## COUNCIL ASSESSMENT REPORT

<b>Panel Reference</b>	PPSSNH-727
<b>DA Number</b>	eDA0470/25
<b>LGA</b>	Ku-ring-gai
<b>Proposed Development</b>	Tree removal, construction of a 9 storey residential flat building over 3 levels of basement parking plus associated landscaping and civil works
<b>Street Address</b>	4 Cherry Street, Warrawee
<b>Applicant</b>	Celesteem Turramurra Development Pty Ltd
<b>Date of DA lodgement</b>	04/09/2025
<b>Total number of Submissions</b> <b>Number of Unique Objections</b>	62 objections received during notification period 7 objections received during renotification period
<b>Recommendation</b>	Refusal
<b>Regional Development Criteria: Schedule 6 of the SEPP (Planning Systems) 2021</b>	Estimated development cost of greater than \$30 million
<b>List of all relevant s4.15(1)(a) matters</b>	<ul style="list-style-type: none"> <li>• Environmental Planning and Assessment Act 1979</li> <li>• Environmental Planning and Assessment Regulation 2021</li> <li>• Environmental Planning and Assessment (Savings, Transitional and Other Provisions) Regulation 2017</li> <li>• State Environmental Planning Policy (Resilience and Hazards) 2021</li> <li>• State Environmental Planni

**Figure 5 – North elevation of the proposed development, facing the Laurel Avenue / King Street HCA**

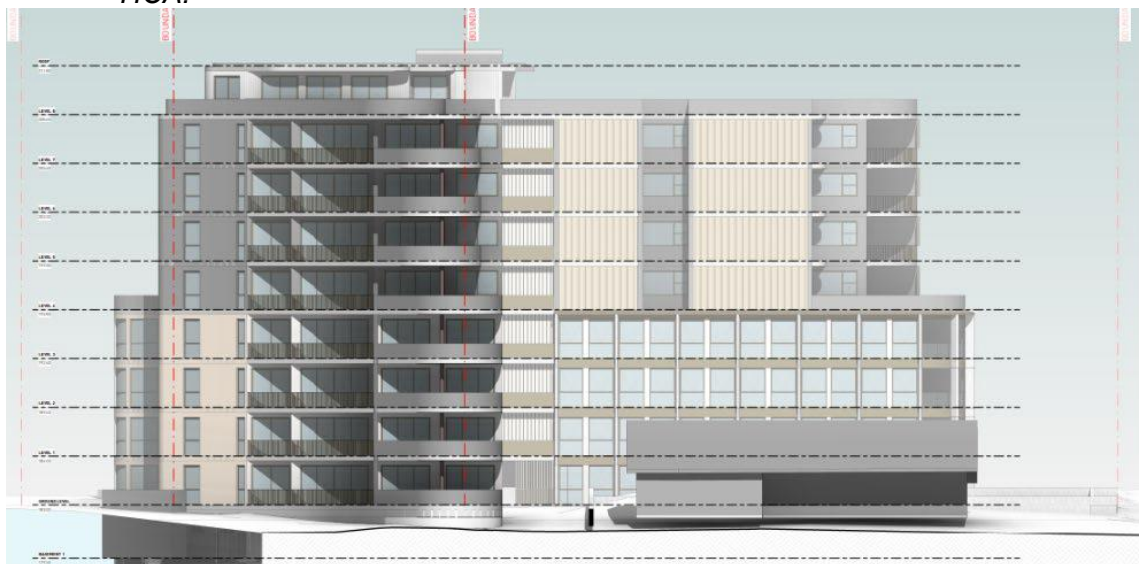
- i. As the proposed development is approximately 30 metres high, its upper levels would be visible from the significant items and areas. The proposed building mass has deep recesses (**Figure 4**), will result in a strong visual contrast between shaded areas in the balconies versus bright sunlit areas on the northern elevation, which is facing the HCA and against the sky.
- ii. The proposed building design utilises materials which are not compatible with traditional imagery of the context, including metal façade elements and profiled concrete elements (**Figures 5 and 6**).

*Image 01: Screenshot of the ground floor Level*

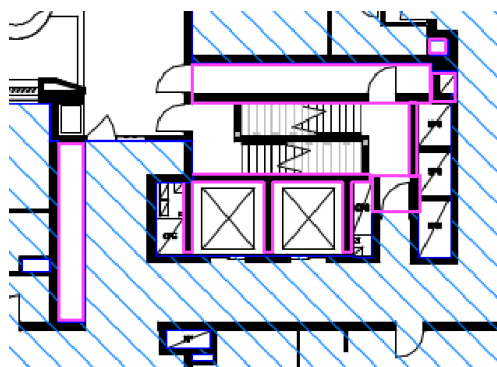
- a) The areas of GFA that have been incorrectly excluded are identified in the screenshot below (highlighted in pink):

Image 02: Screenshot of Level 1-8

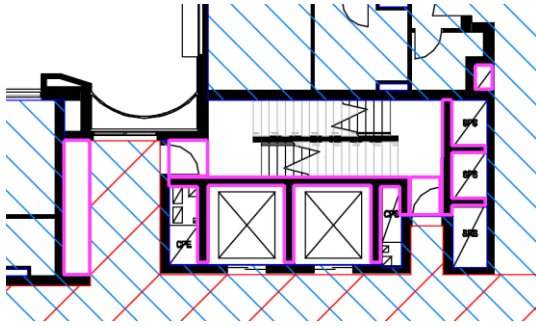
- b) The thickness of internal walls enclosing common vertical circulation (e.g. lifts and stairs), as well as the thickness of walls to risers, must be included in the GFA calculation.

Image 03: Screenshot of Level 4

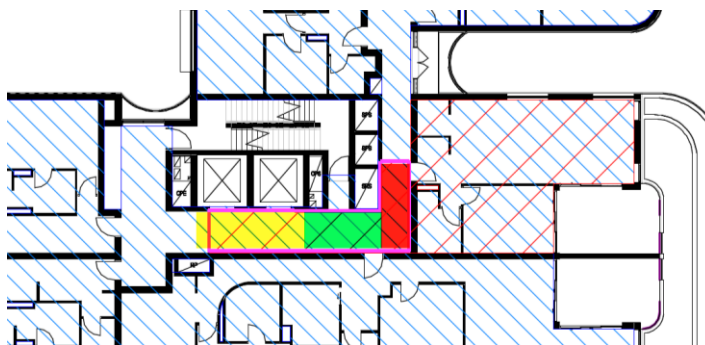
- i. The yellow-hatched area serves 6 units, including the affordable units
  - ii. The green-hatched area serves 4 units, including the affordable units

- iii. The red-hatched area serves 3 units, including the affordable units

- h) This issue occurs on multiple levels where affordable units are proposed.
